From: Peabody, Daniel (EGLE)
Sent: Saturday, June 6, 2020 6:22 PM
To: saric.james@epa.gov
Cc: Williams, Lisa; Miller, Megen (AG); Greg Baker; Ruhala, Sydney (EGLE); Von Wallmenich, Theo/DET; Roberts, Keegan; john kern; Bennett, Brian; Kirchner, Scott
Subject: EGLE Comments_Kalamazoo River _OU5 Area 1_95% Sediment Remedial Design - Crown Vantage Side Channel
Attachments: EGLE_Comments_KalamazooRiver_OU5_Area1 95% Sediment Remedial Design Report CVSC.pdf

**Kalamazoo River Superfund Site
Area 1 95% Sediment Remedial Design - Crown Vantage Side Channel
April 30, 2020**

ALLIED PAPER, INC./PORTAGE CREEK/KALAMAZOO RIVER SUPERFUND SITE		
Area 1		
95% Remedial Design Crown Vantage Side Channel		
DREDGE MANAGEMENT DECISION TREE		
Prepared by/Date: JJH 04/27/2020		FIGURE 10-1
Checked by/Date: MTP 04/27/2020		
Project Number: 3293170001

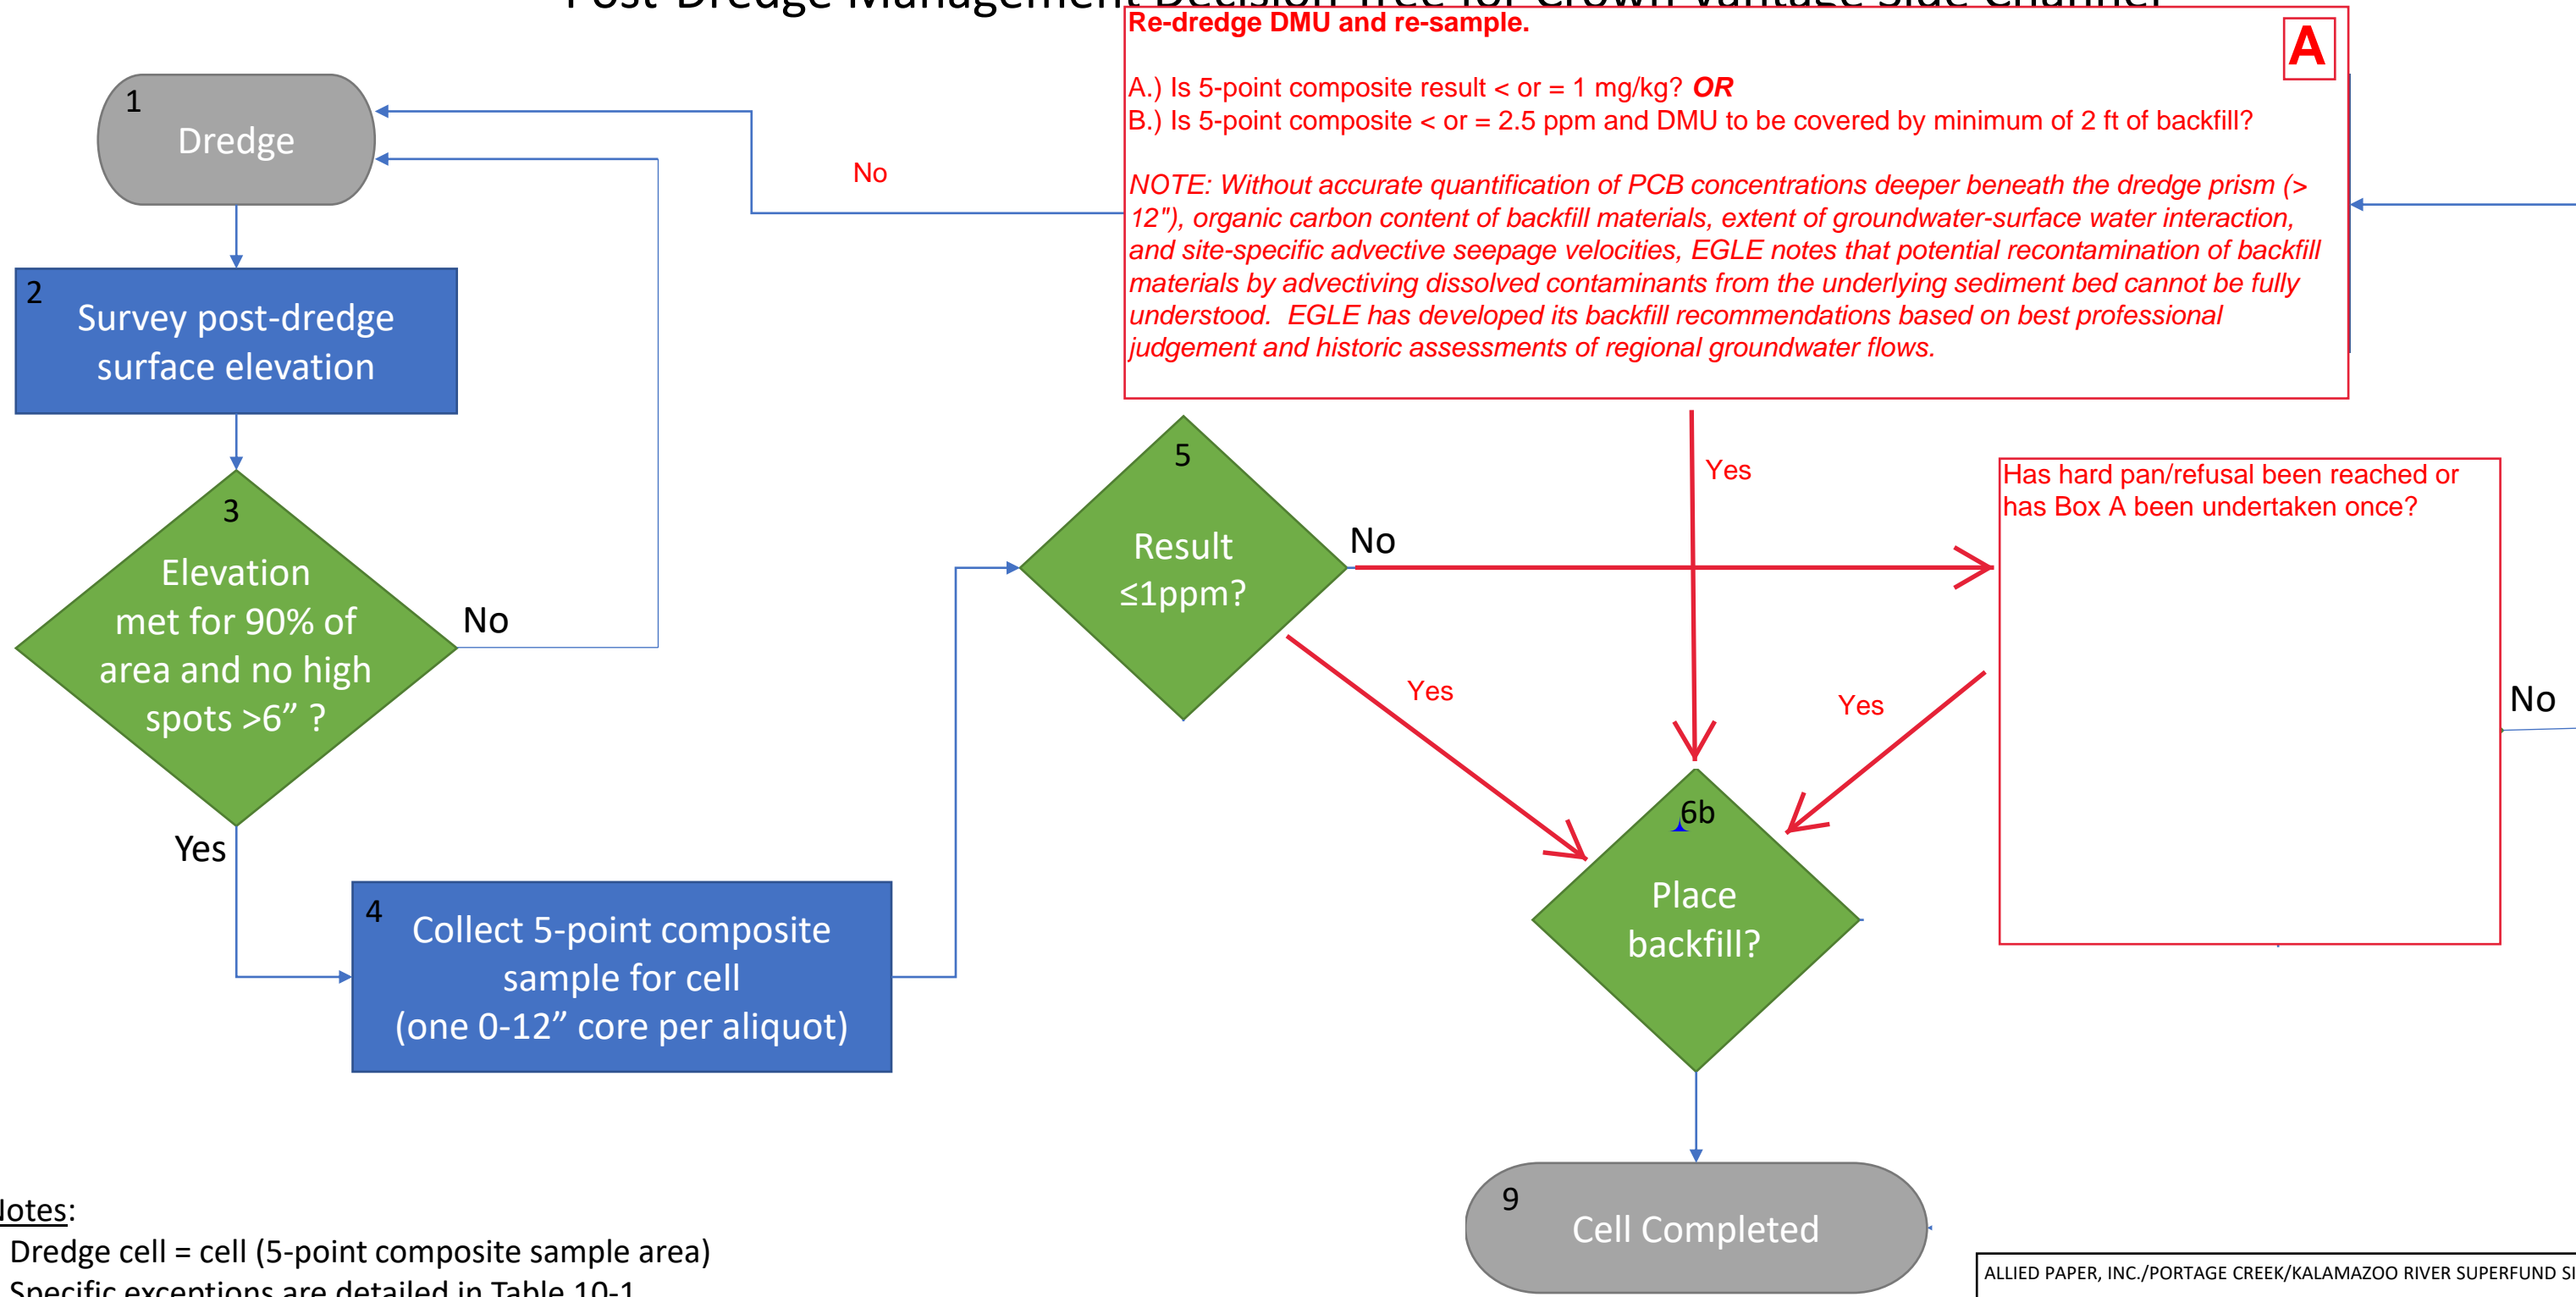
General Comment #2: EGLE believes the post-dredge management and confirmation sampling is not adequate and needs significant revisions. Firstly, the post-dredge management decision tree provided in Figure 10-1 proposes that a 5-point composite confirmation sample will be collected in cells that meet the post-dredge surface elevation criteria. If the composite analytical result is ≤ 1 ppm, a cell is proposed to be complete. For results >1 ppm but less <10 ppm, a backfill cover of at least 1 foot is proposed to manage the residual concentrations. If results are >10 ppm, re-dredging is proposed to take place if a hard bottom has not yet been reached. Please provide an explanation for selecting 10 ppm as the criteria for re-dredging. EGLE is concerned that this criterion may leave a significant amount of material in place with PCB concentrations >10 ppm. EGLE has provided a revised decision tree for consideration.

Secondly, Section 10.3 states that “before re-dredging occurs, the individual aliquots from the 5-point composite confirmation sample may be analyzed and only the portions of the dredge cell representing the aliquots with concentrations above 10 ppm will be re-dredged.” EGLE disagrees with this approach. The intent of the randomized composite sample is to provide an average PCB concentration representative over a given area. If only portions of the dredge cell are to be re-dredged, additional discrete samples would be needed to fully delineate the areas with concentrations above the proposed re-dredge criteria (proposed at 10 ppm). Given that and the known spatial variability of PCBs in sediments at the site, EGLE requests that the entire dredge cell be re-dredged.

Lastly, Table 10-1 states that if a composite sample exceeds 10 ppm, and the results are likely due to generated residuals, then the alternative verification requirement is to analyze 0-6" that represents "generated residuals" and 6-12" that represents "undisturbed residuals". If only the 0-6" sample exceeds 10 ppm, then use a residual cover or backfill. EGLE disagrees with this approach. Under this scenario, post-dredge management should follow the same decision tree as dredge cells without residuals (i.e., the dredge cell would need to be re-dredged). Residuals should not factor into decision making, as previously discussed during technical Work Group meetings.

Specific Comment #16: See EGLE's edited PDF of Figure 10-1 under General Comment #2 for comments on the proposed dredge decision flow chart. Supporting text in the design document should be updated accordingly.

exceeding 10 ppm, and EGLE does not concur with using residuals estimation techniques and the inherent uncertainty associated with them for decision making. Remedial decisions should be driven by empirical evidence. 10 ppm materials should be addressed with further removal under the revised dredge decision flow chart (Figure 10-1) provided by EGLE (see General Comment #2).

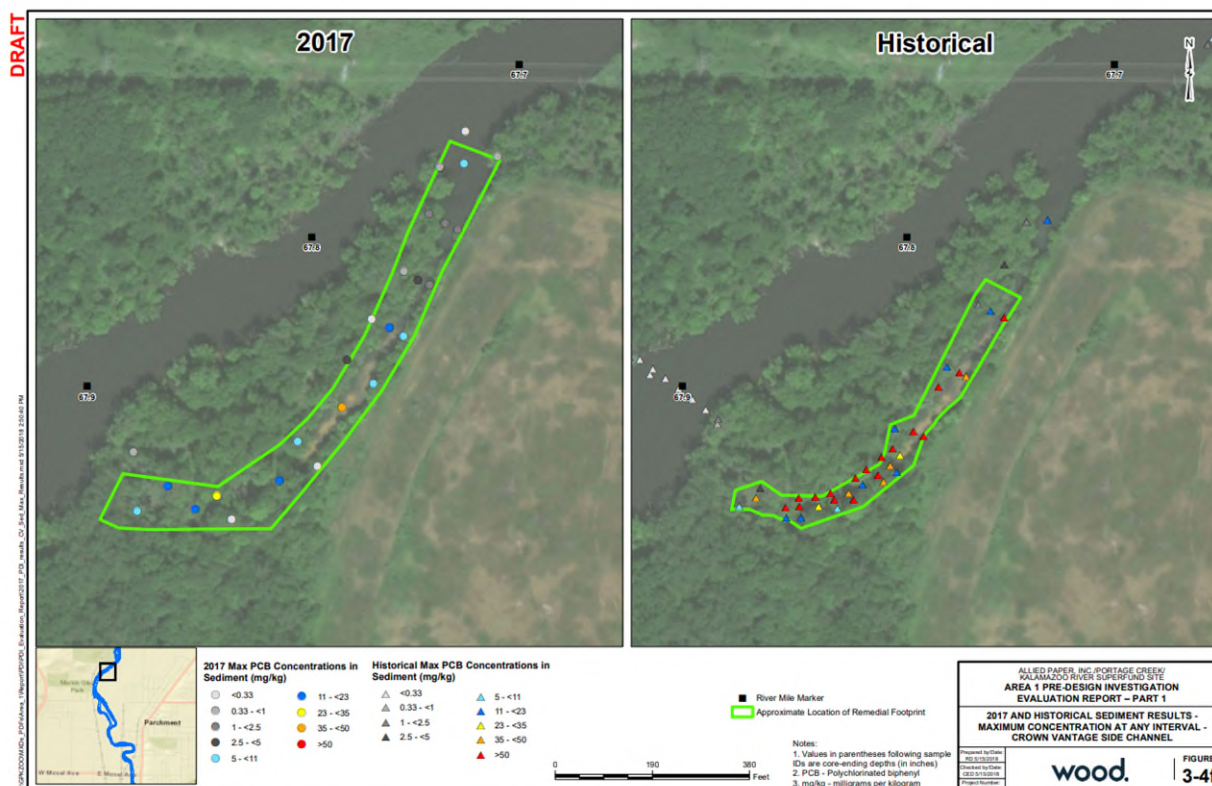
General Comment #4: The decision to abandon SRI data and move forward with PDI data and currently proposed dredge plan may underestimate the concentration of material that will be encountered in the field and potentially result in an incomplete removal and/or exposure or liberation of underlying sediments that are also known to be contaminated. Ignoring historical data and the conceptual model could also lead to inappropriate handling and disposal of dredged sediments. EGLE continues to believe that the conceptual model developed by GP and supported by the Agencies for the crown vantage side channel (CVSC) lends itself consideration of all data and not just the PDI data, which we also know is biased low. Relevant text related to the conceptual model is inserted below.

higher in concentration as shown in Figure 3-4f from the PDI Report (inserted below). The PCB concentrations in sediments are also discussed in the text of each document although the descriptions provide vastly different views of the nature and extent of PCB contamination in the CVSC. Portions of relevant text from the SRI and PDI report is included below.

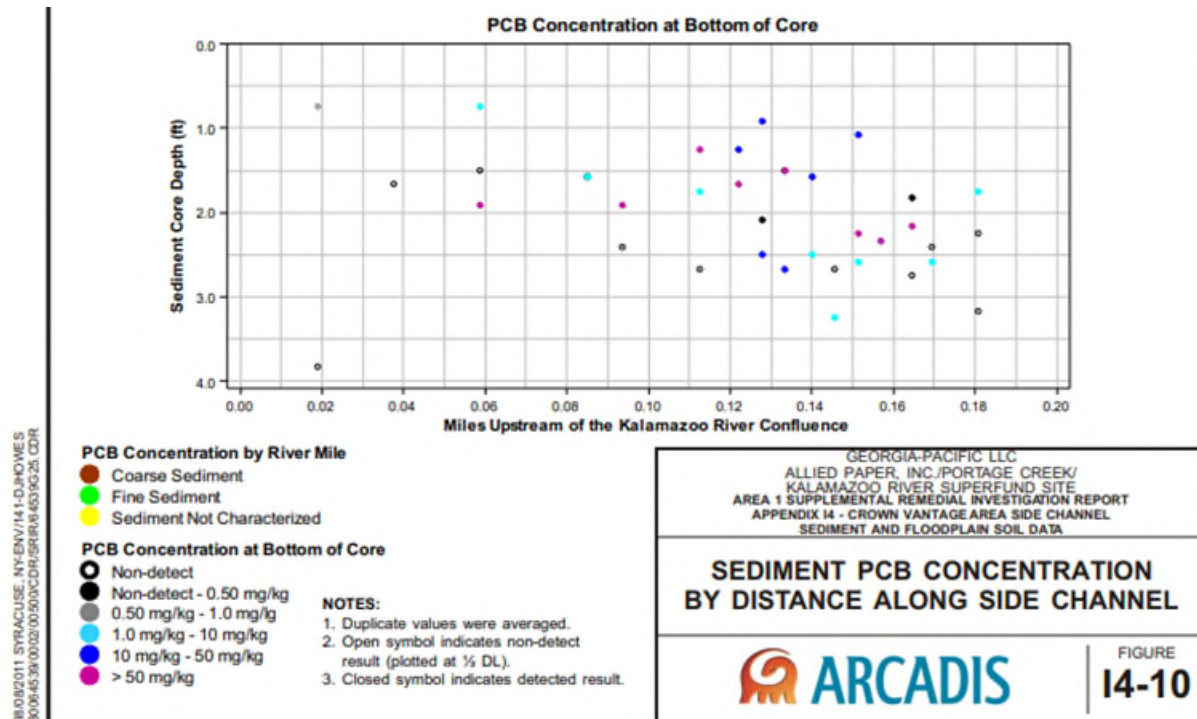
The 2020 95% Sediment Remedial Design - CVSC states PDI sampling concluded that the PCB impacts are limited to the upper 2-feet and proposes a 3-foot cut in DMU 1 and a 2-foot cut in DMU 2. However, the SRI text (summarized above) and data collected by GP and shown in Figure I4-10 in the 2012 SRI Report (inserted below) shows PCB impacts above 1 mg/kg present in sediments below 2-feet. For reference, on the figure below, DMU1 would extend from approximately 0.00 to 0.14 miles and DMU2 would extend from approximately 0.14 miles to 0.18 miles.

3. The 3-foot dredge cut for DMU2 should be extended to at least cover the locations where SRI data showed impacts below 2-feet (approx. 0.03-miles further than what is proposed) and then adjusted further downstream, if necessary, based on results of confirmation sampling.

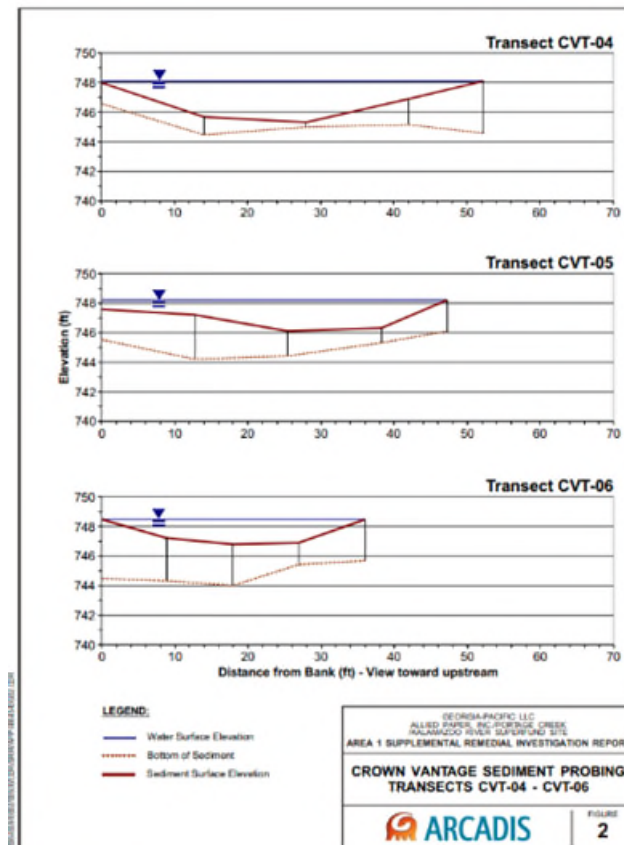
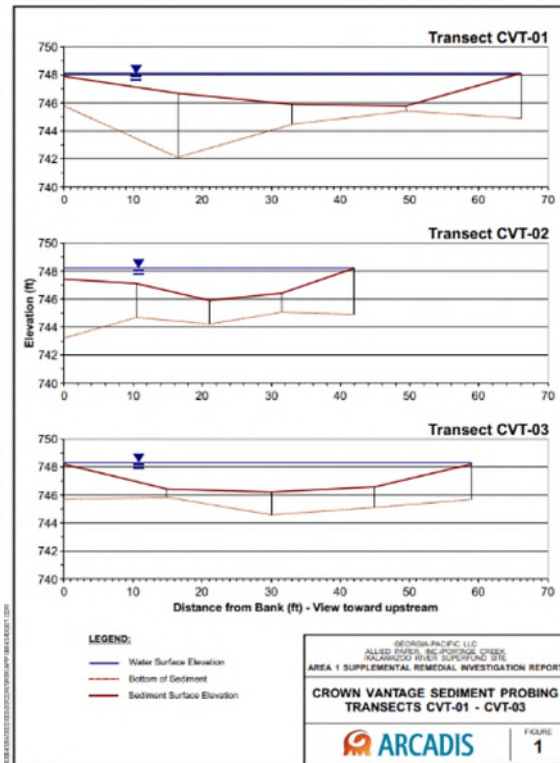
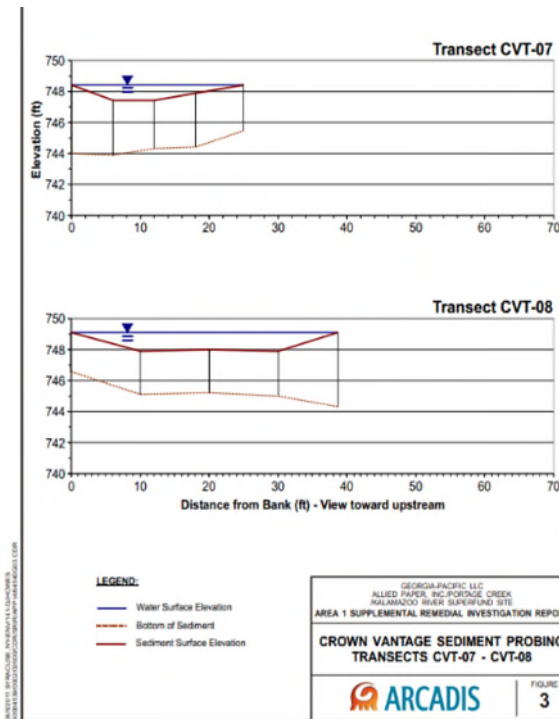
The SRI also described the contact between the generally coarser and less organic rich sediments that were deposited prior to damming off the side channel and the fine grained organic rich deposits that accumulated as water flow through this area was reduced, as well as presence of significant PCB impacts deeper than 2-feet, the heterogeneous nature of PCB distribution within localized areas in the CVSC, and variable sediment thicknesses across the channel. Portions of relevant text from Appendix I4 of the Area 1 SRI is inserted below.

4. Targeted removal of additional deeper soft sediments to account for greater soft sediment thicknesses than the proposed dredge cuts in DMU1 and DMU2, particularly near the edge of the channel. Variation in soft sediment thickness across the channel may not be as apparent in the PDI data due to the randomized sampling approach that was used but is clearly present in the transect based sampling and probing completed during the SRI.
